2.3 Radiation Monitoring Systems

The information in this section of the ABWR DCD, including all subsections, tables, and figures, is incorporated by reference with the following departures.

Figure 2.3.1 Process Radiation Monitoring System Control Interface Diagram

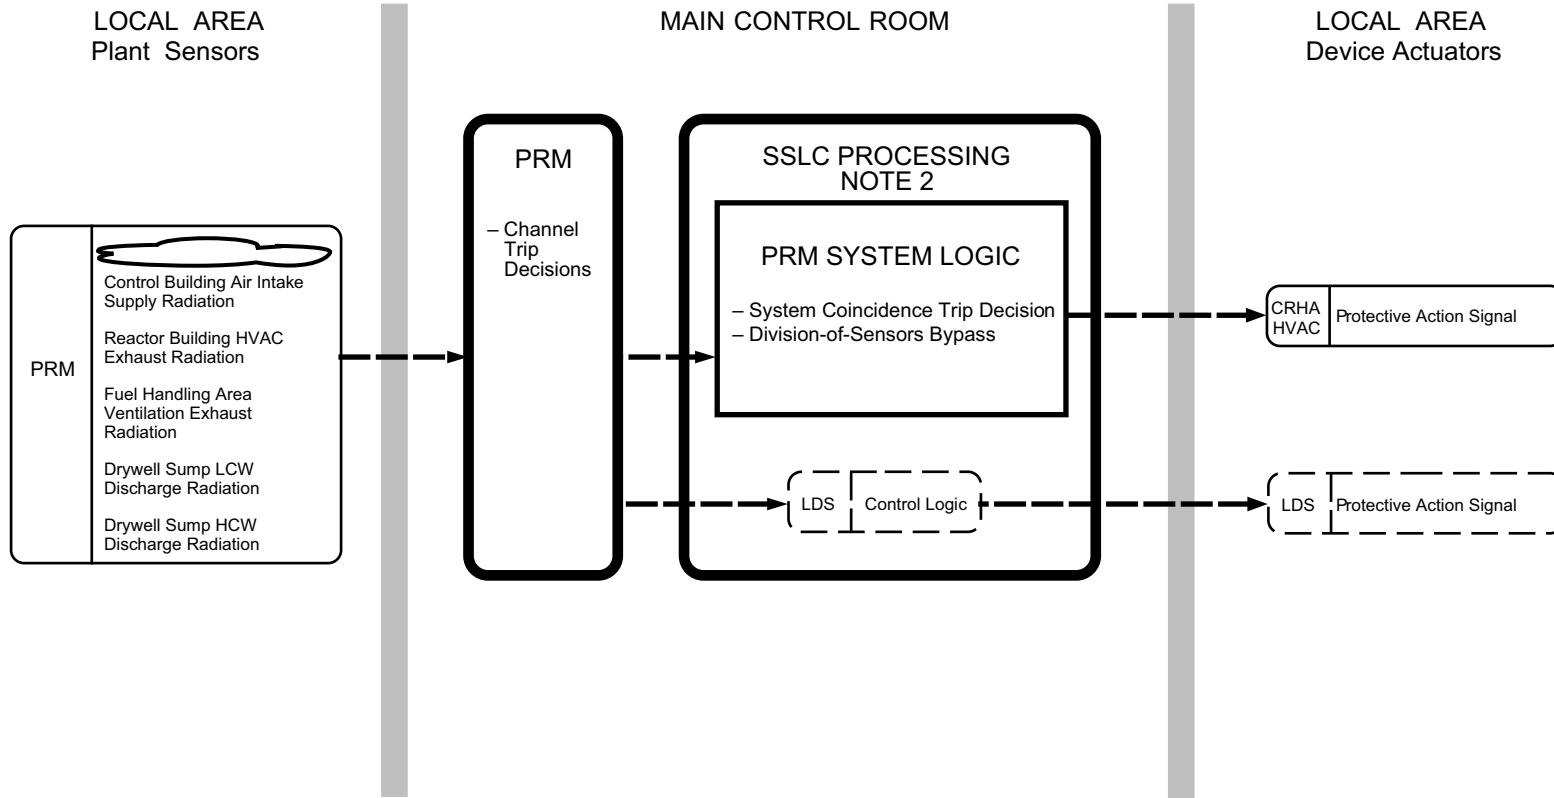
STD DEP T1 2.3-1 (Figure 2.3.1)

STD DEP T1 2.3-1

Portions of the PRM System are classified as Class 1E safety-related (items 42 through 5 below); the remainder are classified as non-safety-related.
